RE: Class 2 Permissive Change
FCC ID: 2AWYY-BETA

Sana Health, Inc. would like to request a Class 2 permissive change for our Beta product. Due to an error, the non-feed end of the chip antenna was grounded, contrary to the specifications of the chip antenna vendor. The new revision of the board corrects that error. No other changes were made to the device design or software.

In the current version, the schematic for the antenna signal path is:

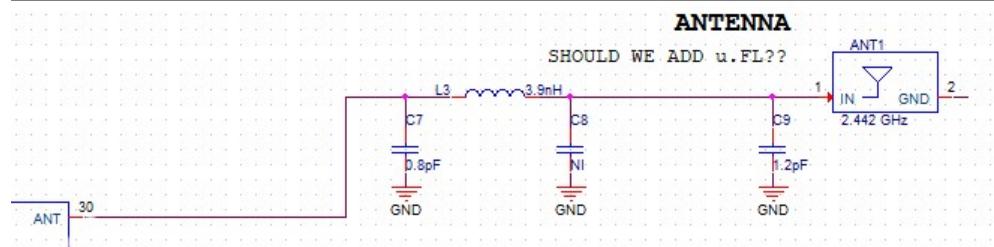
In the new revision, the GND connection to ANT1 was removed per the vendor's specification.

Vendor's specification for the 2450AT18B100 chip antenna.	The layout change involved deleting the two traces in red on the bottom side of the board. The round pads to the right of the chip antenna are tied to ground.
